## SEWAGE DISPOSAL SYSTEM

HOWARD COUNTY HEALTH DEPARTMENT

SUBDIVISION Warfield's Estates LOT 31, Blk.C ROAD 14821 Burntwoods Road

REPAIR - PURPOSE - IN SUPPORT OF FUTURE BUILDING PERMIT APPLICATION FOR A 3 BEDROOM ADDITION.  
Call for inspection when ground is opened so sanitarian can recommend repair.

512699

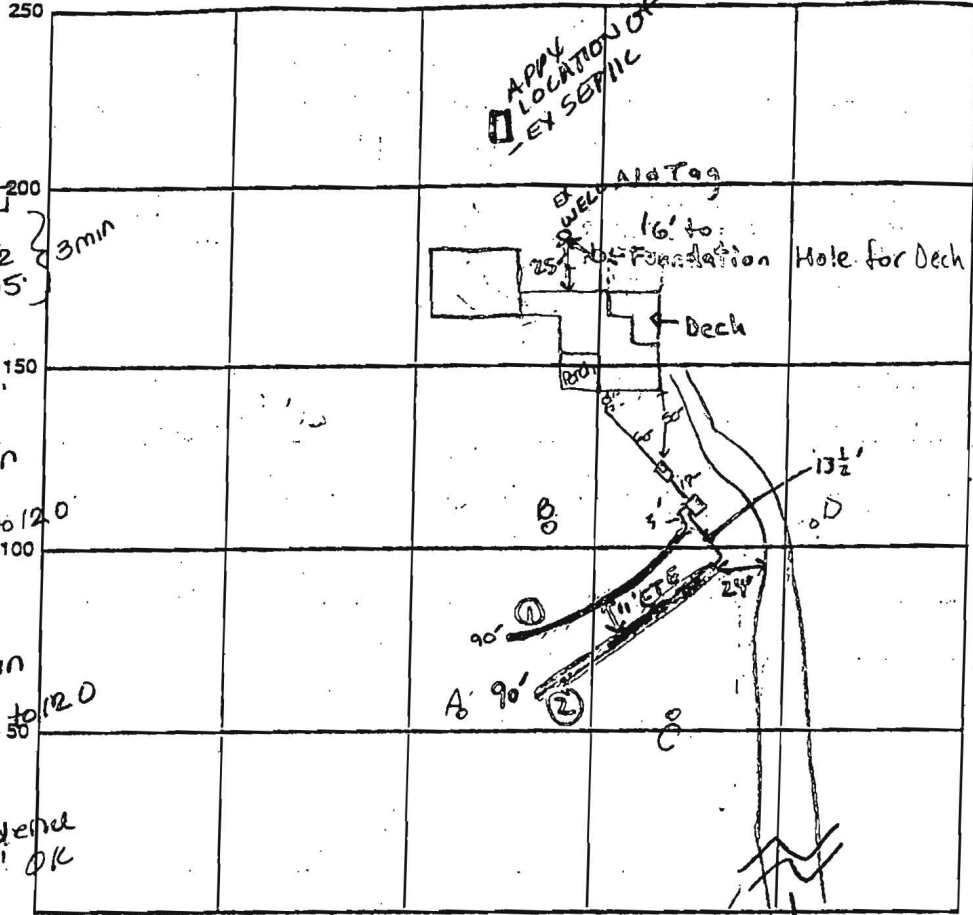
Begin trenches @ test hole B - also abandon existing septic system

Hole for Deck ext. No BP approved for this ext. Spoke to Mr. Bowlings he agreed he would not build this. Building inspector Bruce Forst was notified. SRK to enforce this.

REMARKS: 9/13/99 A.M. OK to cover from house to dist. box.

OK to stone 1<sup>st</sup> trench and continue work. DIS

9/13/99 P.M. OK to cover 1<sup>st</sup> trench and continue.

(\* owner may choose to maintain ex. system to serve ex. structure due to difficulty w/ plumbing issues) DIS

9/14/99-OK TO COVER ALL WORK-SRK
